SUBJECT: REVISION "A" TO TECHNICAL BULLETIN 212-99-181:

**FUEL PUMP LARGER DIAMETER DRAIN LINES,
INTRODUCTION OF**

No. 212-99-181

REV A

Figure 1

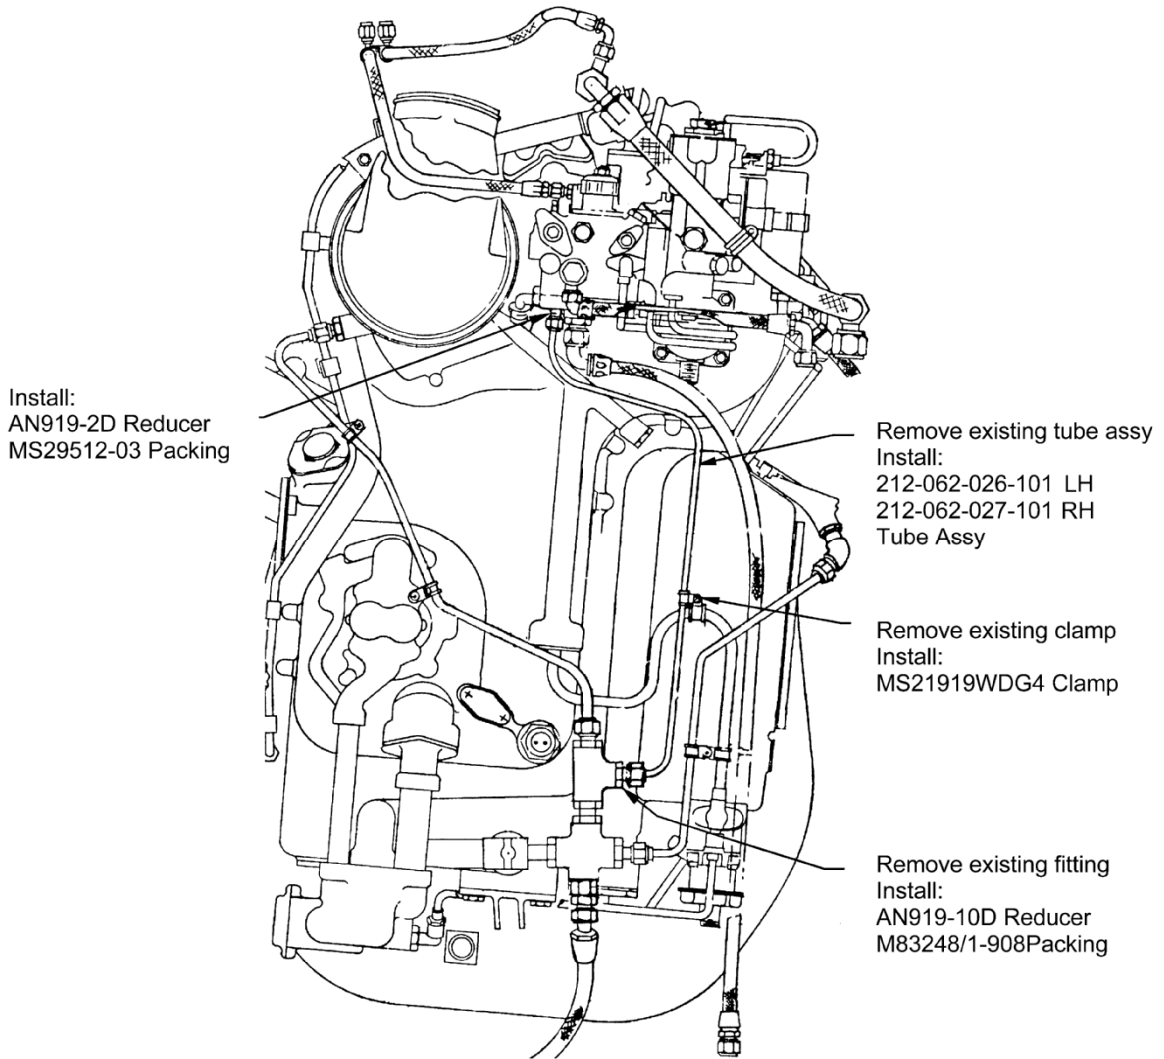
Revision "A" to this bulletin corrects a typing error on figure 1 of the bulletin. Tube P/N 212-062-026-101 should be on the L/H side and tube 212-062-027-101 should be on the R/H side.
